CTFS4880F-225WSA-WHT
NEEDLE VALVE ASSEMBLY, PANEL MOUNTED, FLOWSTOP

Drawing Number: WUIS-05

SUBMITTAL IDENTIFICATION SHEET

WEBSTER UNIVERSITY ISB	
PROJECT NAME	
8274 BIG BEND BLVD	
ADDRESS	
NUMBER	
WEBSTER UNIVERSITY	
OWNER	
CANNON DESIGN	
ARCHITECT / ENGINEER	
DEVIN D GATES	
SUBMITTED BY	
123553-001 REV 2	
CONTRACTOR / CM SUBMITTAL NO.	CANNON DESIGN SUBMITTAL NO.
	123553
DRAWING / DETAIL REFERENCE	SPECIFICATION SECTION / PARAGRAPH
MANUFACTURER / SUPPLIER	ITEM / PRODUCT ID
REQUIRED DATE	PRIORITY
	CRITICAL

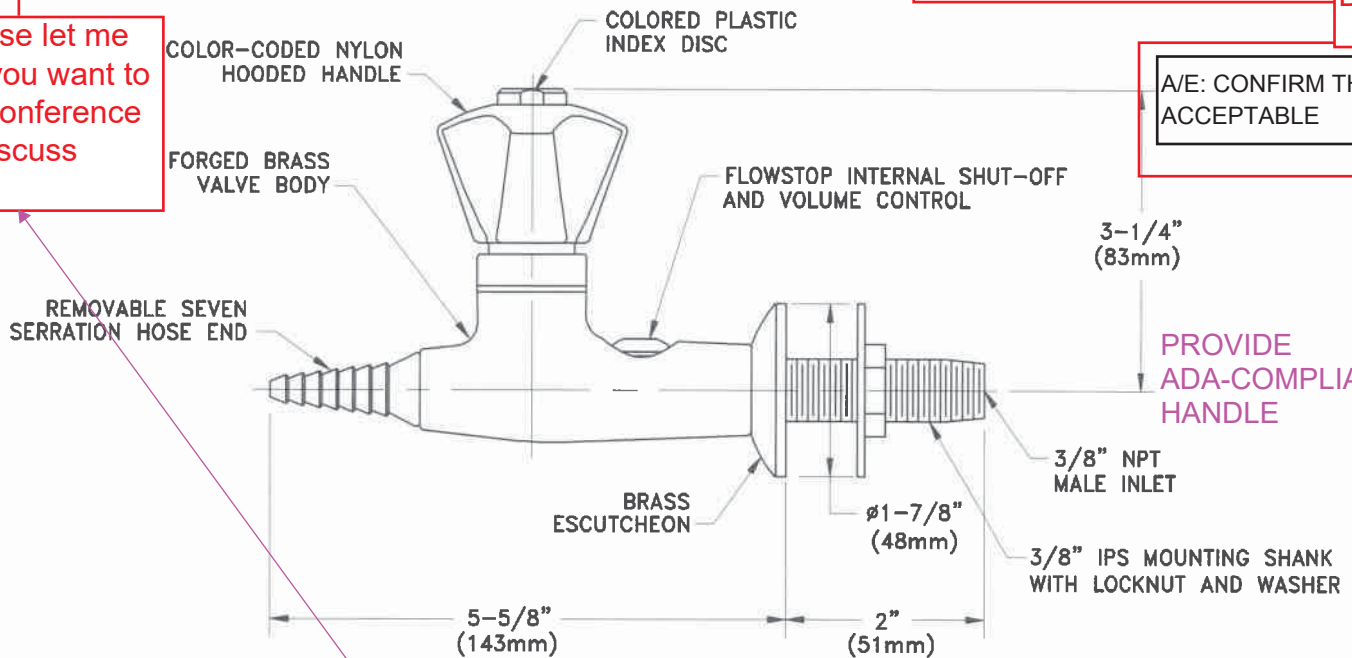
NOTE: VERIFY HOW THIS FIXTURE WILL
WORK WITH BIOSAFETY CABINETS.

NOTE: THIS NEEDLE VALVE FIXTURE
CANNOT BE PROVIDED WITH A BLADE
HANDLE.

A/E: CONFIRM THIS IS
ACCEPTABLE

A/E please let me
know if you want to
have a conference
call to discuss
DG

PROVIDE
ADA-COMPLIANT
HANDLE

FOR A-4 & V-4, PROVIDE
SUITABLE VALVE FOR
CONNECTION TO BIOSAFETY
CABINETS (OFOI).
COORDINATE WITH OWNER.
